APPLICATION NO.	FILING DATE	FIRST NAMED INVENTOR	ATTORNEY DOCKET NO.	CONFIRMATION NO.
10/763,630	01/24/2004	Russell Dennis	RD9-03-001	7726
24207	7590	04/10/2007		
LAURENCE R LETSON P O BOX 4129 LEXINGTON, KY 40544			EXAMINER FERGUSON, MICHAEL P	
			ART UNIT	PAPER NUMBER
			3679	
SHORTENED STATUTORY PERIOD OF RESPONSE		MAIL DATE	DELIVERY MODE	
3 MONTHS		04/10/2007	PAPER

Office Action Summary

DETAILED ACTION

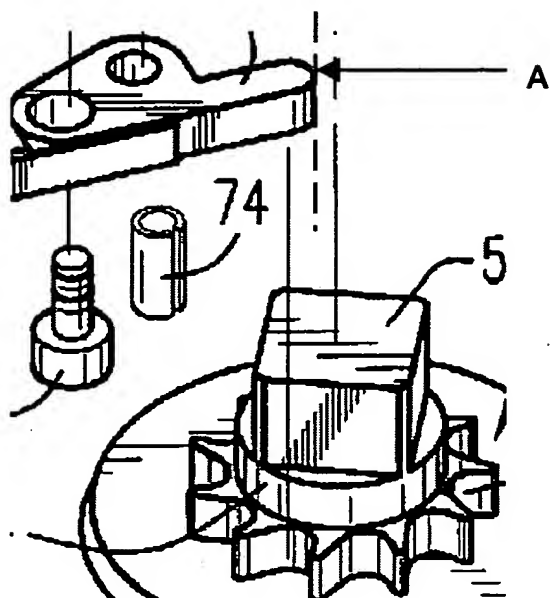
a pawl **70** supported on the body and rotationally movable to engage one end thereof with the tensioner;

a head **58,60** formed on the end of the tensioner for rotation thereof,

the pawl having an engaging end **A** (having a tangential end surface **A**) perpendicular to the pawl and engaging the surface of a portion of the tensioner, thereby blocking rotational movement of the tensioner;

wherein the body supports a pair of tensioners **94,96** for rotation;

a pair of pawls **70** each supported on the body and rotationally moveable to engage one end thereof with one of the tensioners, the pawl having an engaging end (having linear end surface **A**) perpendicular to the pawl, the engaging end further having a planer surface engaging an area on the surface of a portion of the tensioner thereby blocking movement of the tensioner,

each of the tensioners having a head **58,60** formed on the end thereof (Figures 4 and 6).

Examiner notes that a "planar" surface is defined as "a surface in which if any two points are chosen a straight line joining them lies wholly in that surface". Accordingly, all that is structurally required of a "planar" surface is that a linear surface is defined; clearly a linear contact surface exists along linear end surface **A** of the House et al. reference. If the applicant intends to recite an end surface which has both

a width and a length component which are perpendicular to a longitudinal length of the pawl, then such claim limitations should be clearly recited within the claim.

Examiner disagrees. As to claims 1 and 8, as best understood, House et al. disclose a device wherein the pawl **70** has an engaging end **A** (having linear end surface **A**) perpendicular to the pawl, the engaging end further having a planer surface engaging an area on the surface of a portion of the tensioner, thereby blocking movement of the tensioner (Figures 4 and 6).

Examiner notes that a "planar" surface is defined as "a surface in which if any two points are chosen a straight line joining them lies wholly in that surface". Accordingly, all that is structurally required of a "planar" surface is that a linear surface is defined; clearly a linear contact surface exists along linear end surface **A** of the

House et al. reference. If the applicant intends to recite an end surface which has both a width and a length component which are perpendicular to a longitudinal length of the pawl, then such claim limitations should be clearly recited within the claim.
